DEVELOPMENT REVIEW BOARD REPORT

CASE NUMBER/ PROJECT NAME	3-DR-2005 Portales Corporate Center II		
LOCATION	4900 N Scottsdale Road		
REQUEST	Request approval of site plan and elevations for a new office building.		
OWNER	AIG Sun America 602-744-3100	ENGINEER	N/A
ARCHITECT/ DESIGNER	DFD Cornoyer Hedrick 602-912-2567	APPLICANT/ COORDINATOR	Mike Edwards DFD Cornoyer Hedrick 602-912-2567

Stipulations for Case: Portales Corporate Center II 3-DR-2005

Site Plan

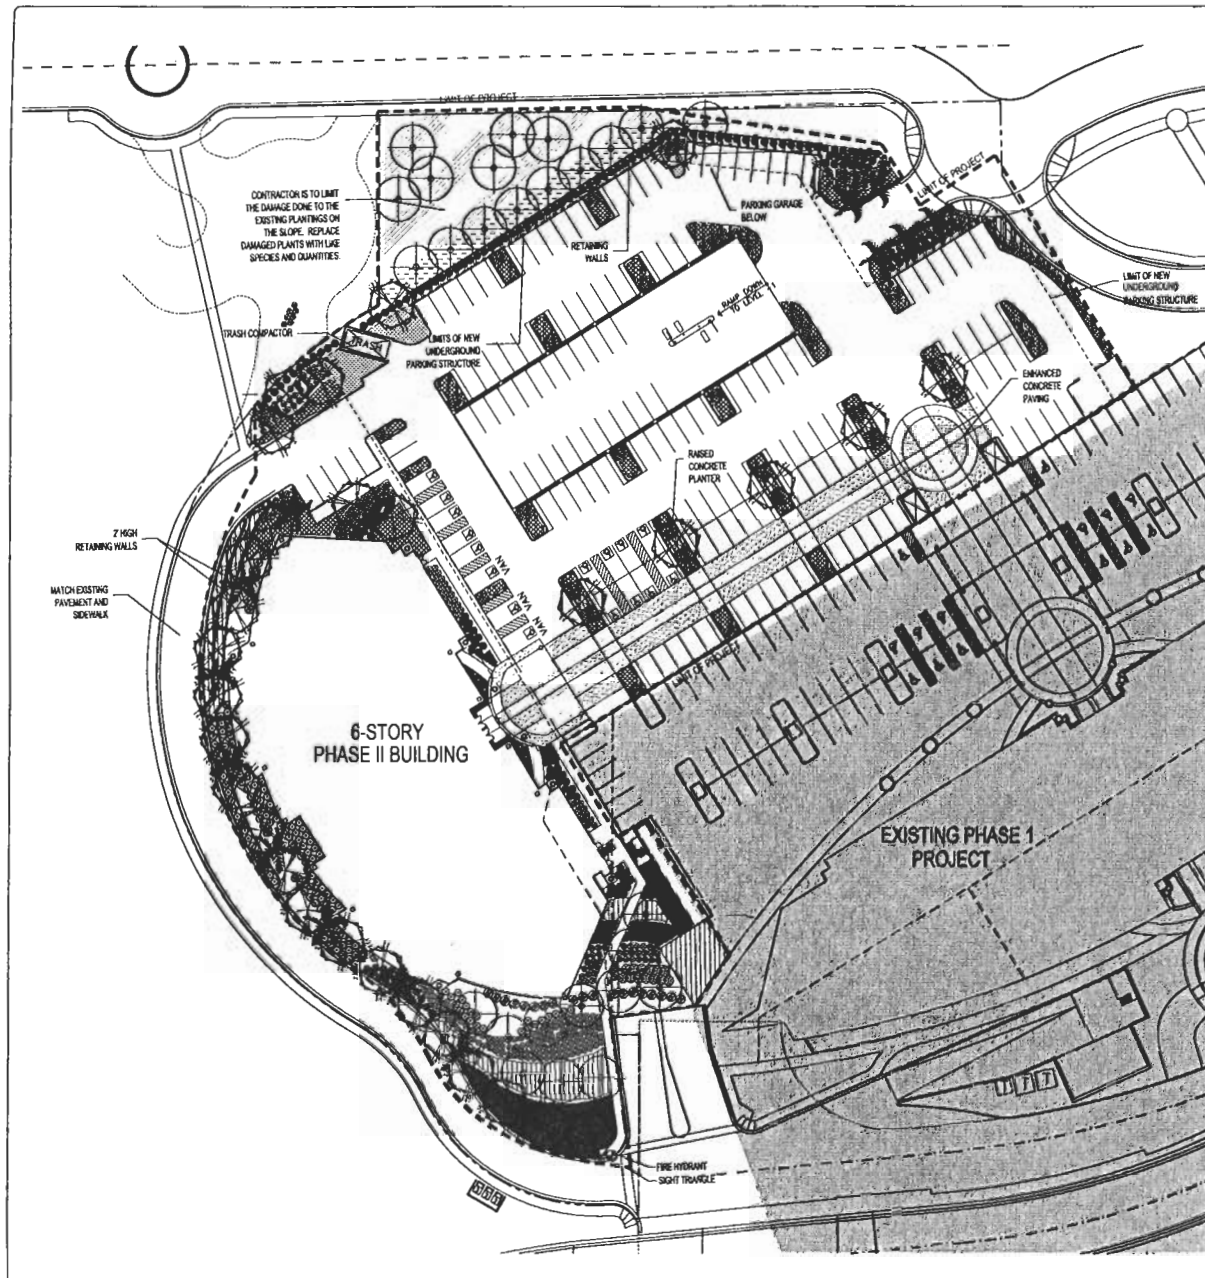
- b. The location and configuration of all site improvements shall be constructed to be consistent with the site plan submitted by DFD Cornoyer Hedrick with a date provided on the plans by City Staff of 3/28/05.

- D. The applicant shall provide landscape medians in the parking lot with a minimum interior curb width of 7 feet and a minimum of 120 SF in area to be counted as provided parking lot landscaping.

- E. The site plan shall be modified to accommodate a minimum of 1/3 of the required parking lot landscaping to be provided in the interior of the parking lot which are not located over structured parking.

Elevations

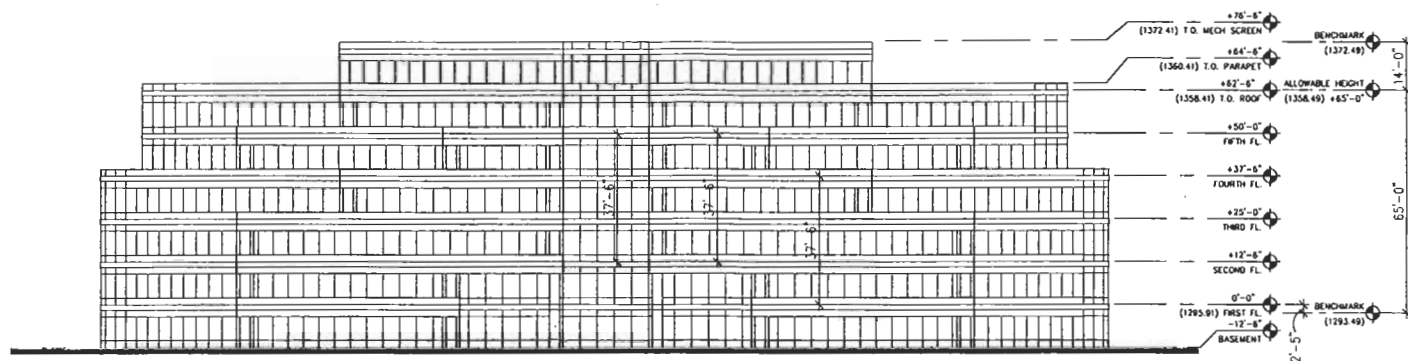
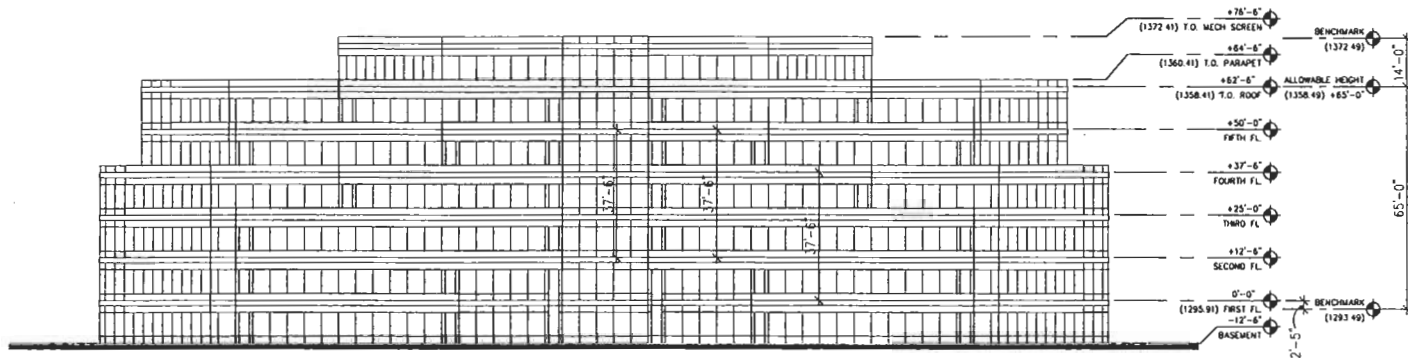
- a. Architectural elements, including dimensions, materials, form, color, and texture, shall be constructed to be consistent with the building elevations submitted by DFD Cornoyer Hedrick with a date provided on the plans by City Staff of 2/11/05.
